Agenda
Village of Arlington Heights
Design Commission
Community Room, 3rd Floor

Arlington Heights Village Hall
33 S. Arlington Heights Road
Arlington Heights, IL 60005
October 10, 2017
6:30 PM

A. 107 N. Pine Ave. - SF/New - DC#17-070

A. AT&T - 585 E. Palatine Rd. - Commercial - DC#17-119

1C
A201
LEFT ELEVATION

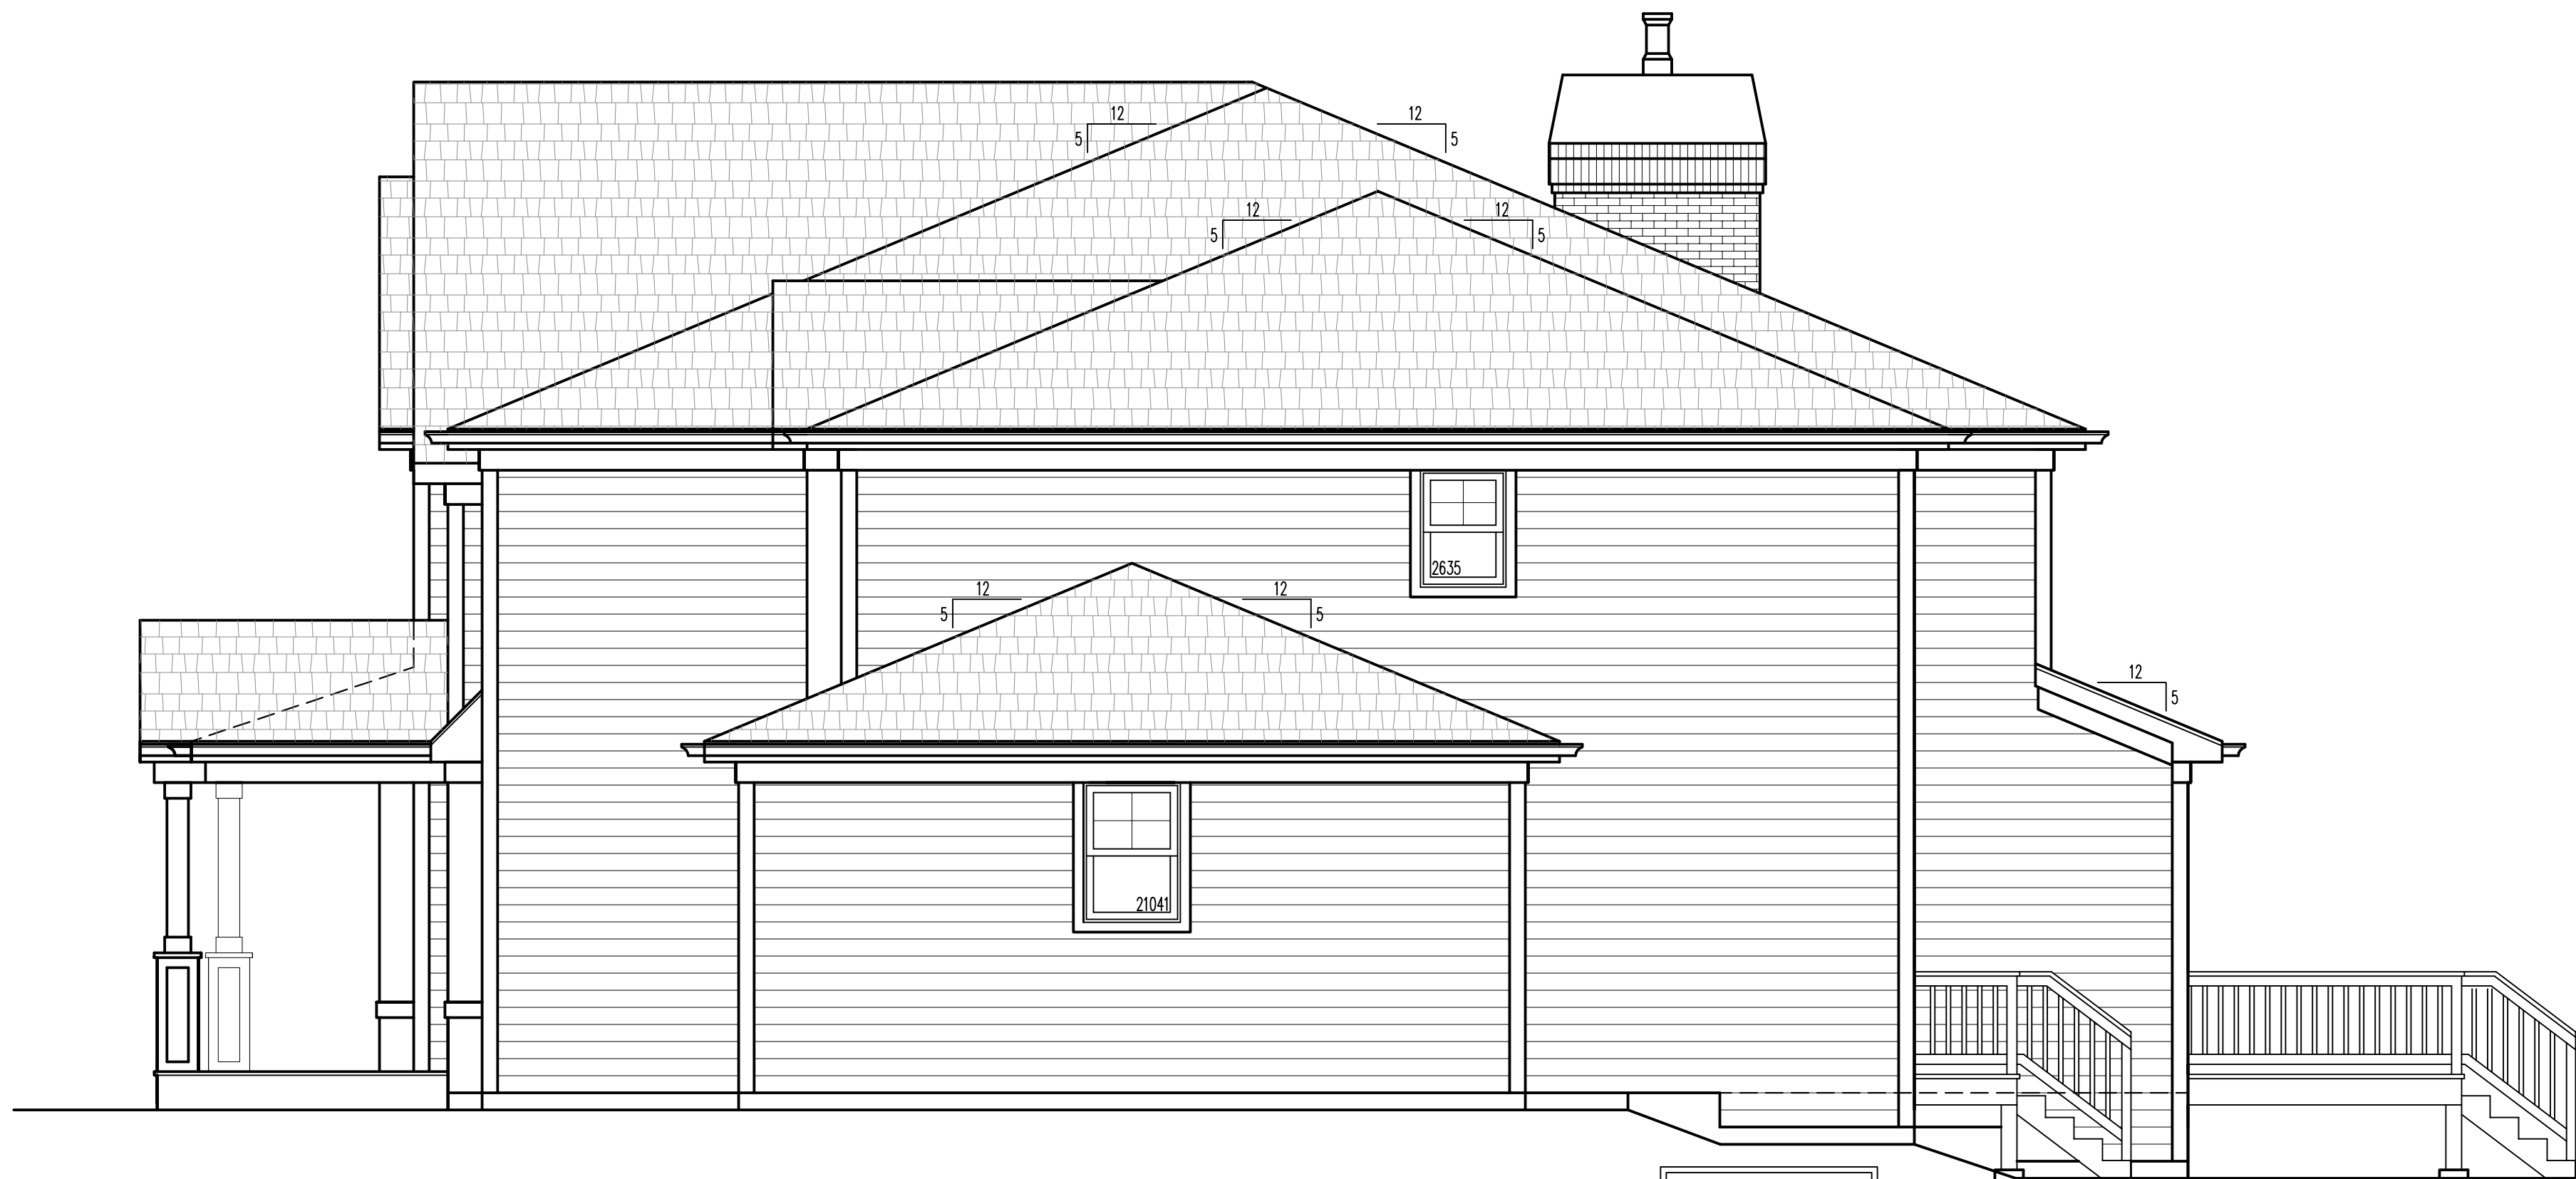
1. Add at least one window on the side of the Dining Room, similar to the window in the Library.
2. Evaluate the proposed exterior colors. Consider a lighter gray or earth tone siding color.

The side elevations could benefit from additional windows. It is recommended to at least add one window on the side of the Dining Room, similar to the window in the Library.
